CITY OF ALBUQUERQUE

RE: Heritage Marketplace Tract C3
1720 Unser Blvd
Conceptual Grading and Drainage Plan
Engineer's Stamp Date 8/11/17 (File: H09D027)

Based on the information provided in your submittal received 8/15/17, the Grading and Drainage Plan is approved for Building Permit. Prior to Certificate of Occupancy the following condition will need to be met:

HERITAGE MARKET PLACE — TRACT (1720 UNSER BLVD NW ALBUQUERQUE, NEW MEXICO 87120	PROJECT MANAGER JOB NO. DRAWN	JEFF WOOTEN 2016029 JEFF WOC	SHEET TITLE	Grading Plan	
HER 1720 ALBU(PROJECT MA	JEFF	SHEET TITLE	Gro	
TE:		sheet-			ĺ
B/11/2017			1	1

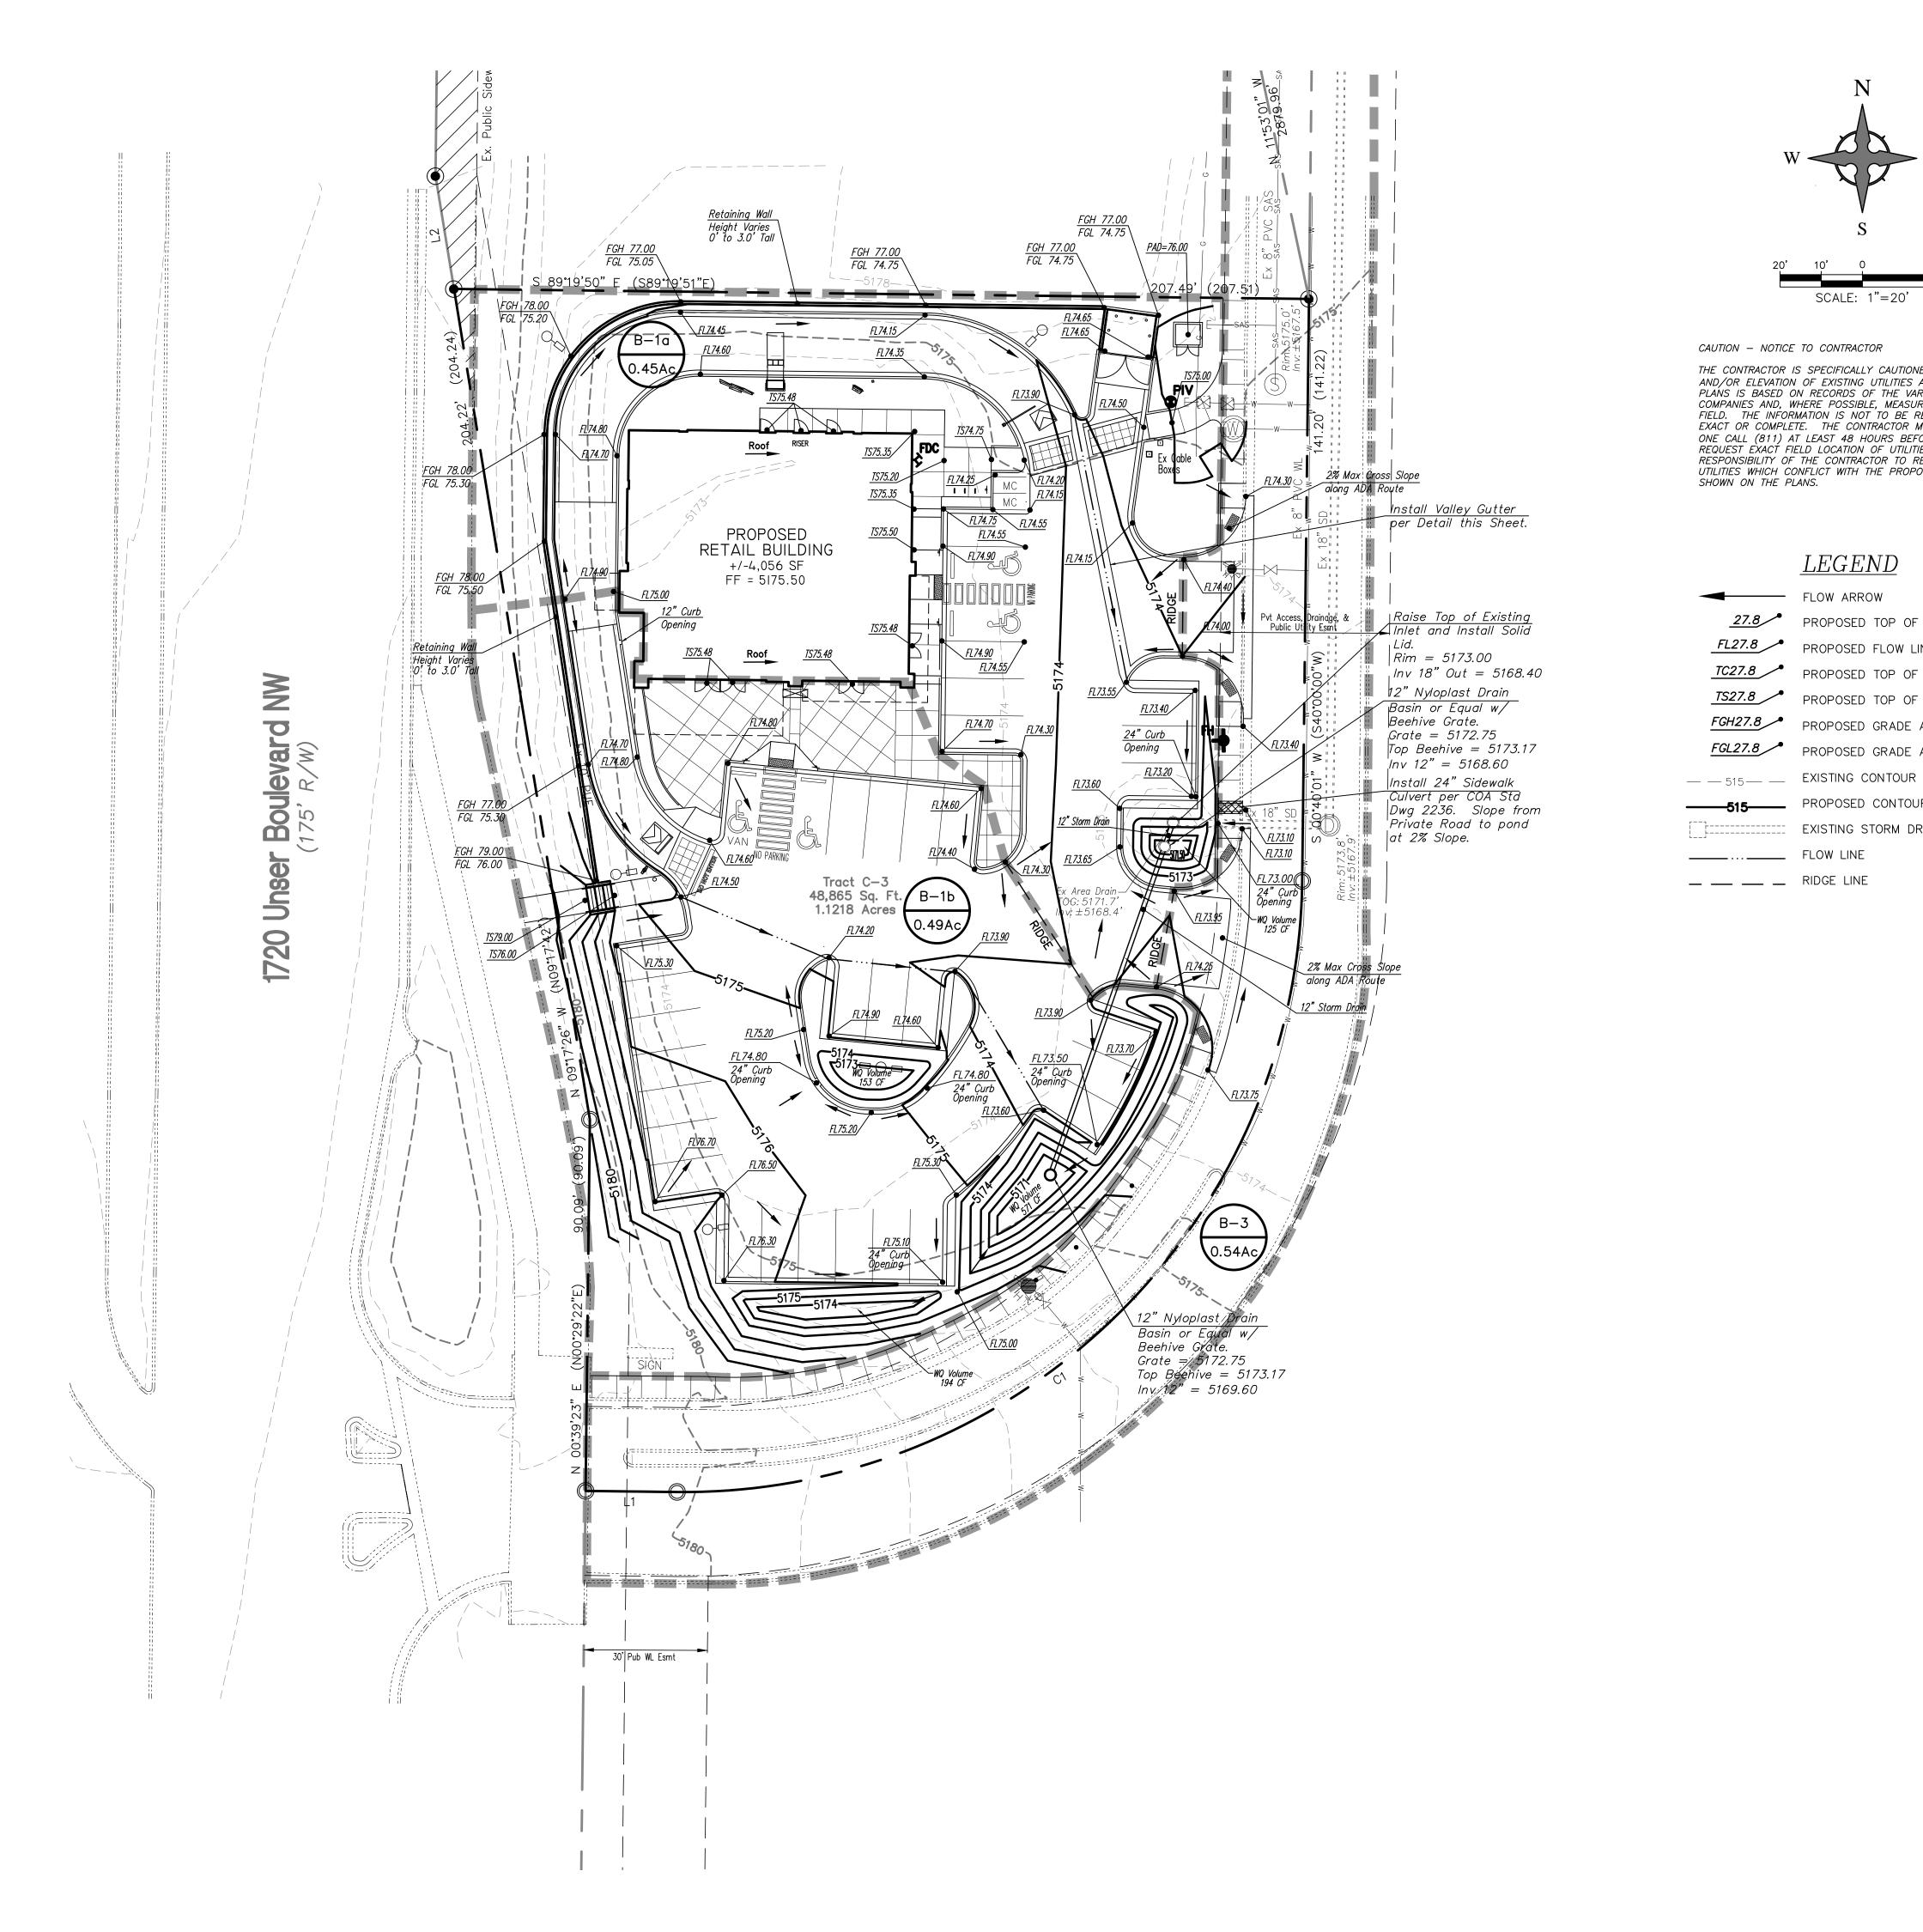
1. A Bernalillo County Recorded Private Facility Drainage Covenant is required on the ponds.
